MEETING MINUTES

PUBLIC OUTREACH MEETING for KASOLD DRIVE IMPROVEMENTS

from Bob Billings Parkway to 6th Street

7:00pm-9:00pm, Wednesday, May 27, 2015, Christ Community Church, 1100 Kasold Drive

Kasold Drive Improvements
Lawrence, KS
Kasold Drive and Harvard Road
Options 1 & 2

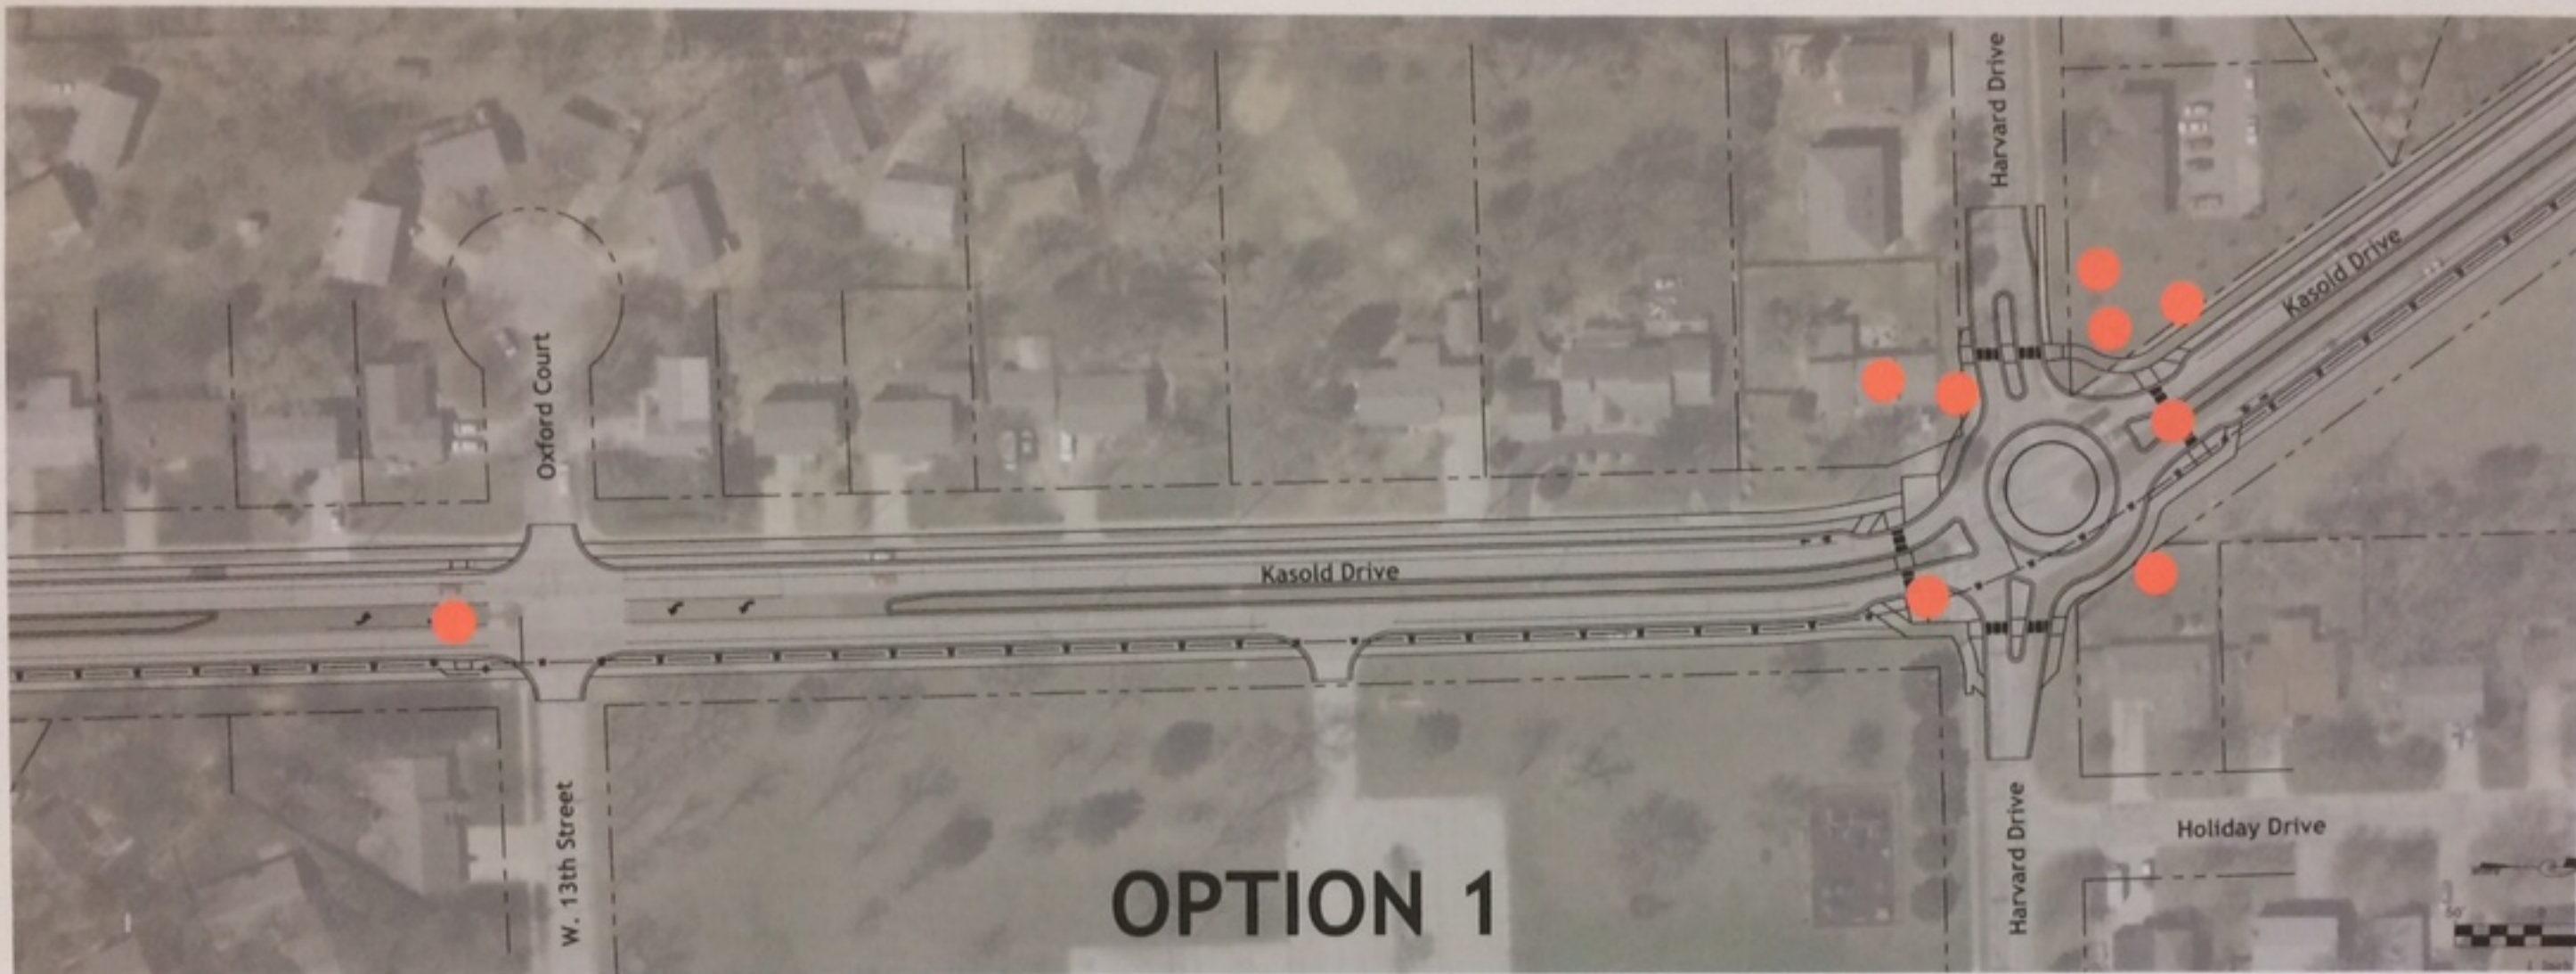
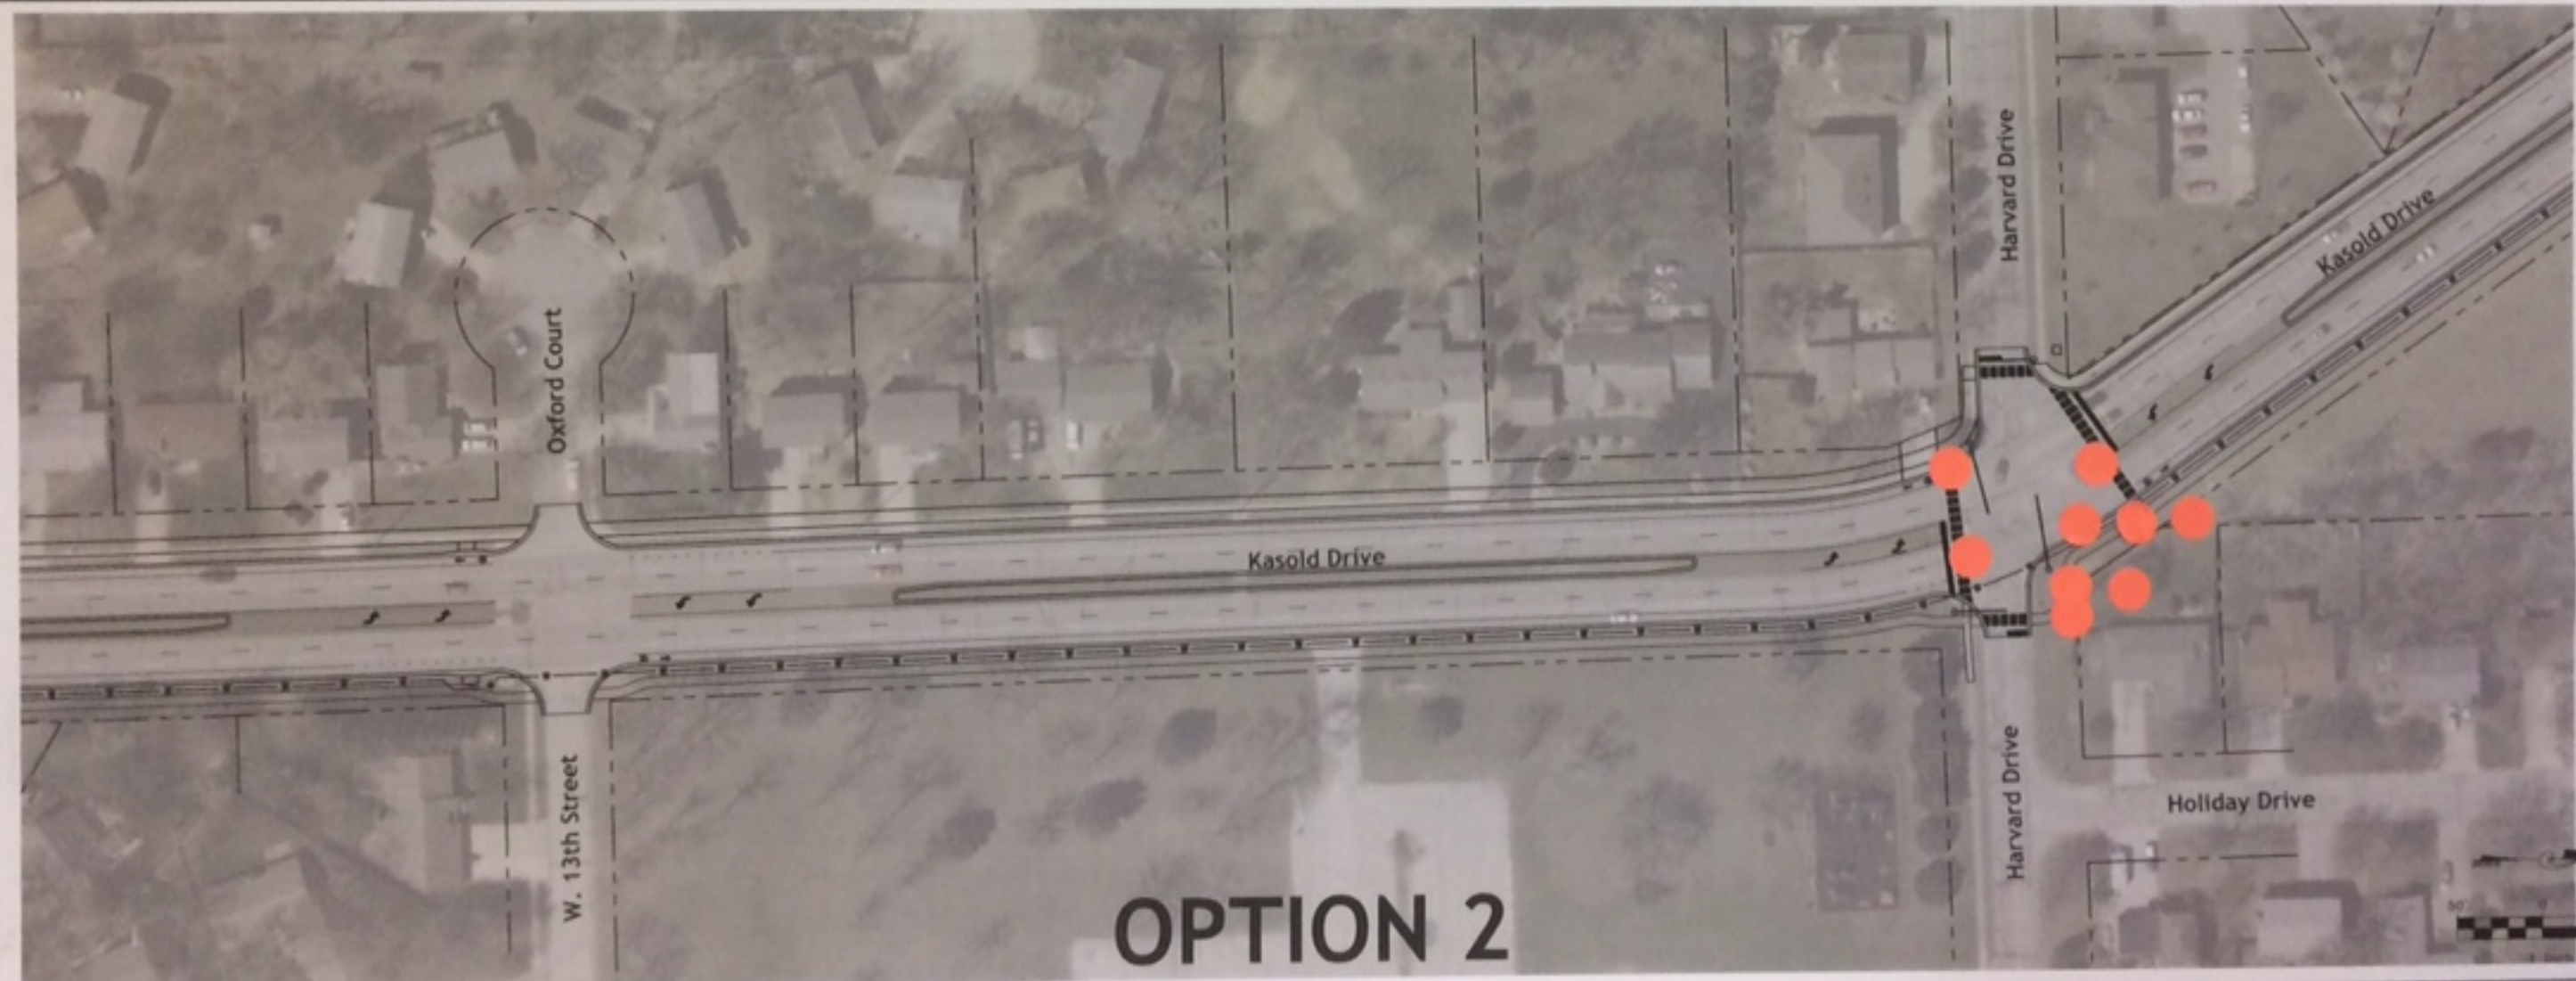
- I am in favor of Option 2. This is a difficult intersection that will be made more difficult and dangerous to children and families if a traffic roundabout is put in. Children cross the road coming and going to and from school as well as the church playground on the corner. A traffic light is a better option for the safety in our community.

- I believe Option 2 to be the most beneficial option for the Kasold and Harvard intersection. This is one of the WORST intersections in Lawrence, a signal would offer the much needed control that this heavily used intersection needs. By alternately assigning right of way to various traffic movements, the signal will provide for the orderly movement of conflicting flows. I witness the flaws of this intersection on a daily basis. I also believe it will be a valuable device for improving the safety and efficiency of both pedestrian and vehicular traffic. Children have to cross this intersection to get to and from school during the week, their safety alone should make this choice an easy one. Young families from around the neighborhood frequent the park on the corner of Kasold and Harvard. It is very difficult to get across that huge intersection with children in tow with no light to force oncoming traffic to stop. For those of us that live on Kasold Drive, taking Kasold down to one lane would make it impossible for us to get out of our driveways. The light will not only offer a short break in traffic for us to be able to safely pull out of our driveway, but two lane options to pull out into will help reduce that risk of accidents on Kasold Drive. Thank you for taking the time to read my feedback and hear my vote for OPTION 2-Traffic Light at Harvard and Kasold Drive!

- There is no room for a roundabout at Harvard and Kasold. There is a hill coming from Lawrence Ave on Harvard. Someone topping that hill will have trouble stopping if there is another vehicle in the roundabout, esp. in winter weather. I have not observed any difficulty with the four way stop used now. Drivers seem to function very well with it. Why argue with success and spend money unnecessarily.

- I'm a big fan of option 1 (and single-lane traffic circles). My only concern is with the pedestrian crossing at the Harvard circle that normally has a crossing guard on schooldays. I'd like to see the crossings further from the circle with the east-west crossing, at least, having crossing lights during school hours.
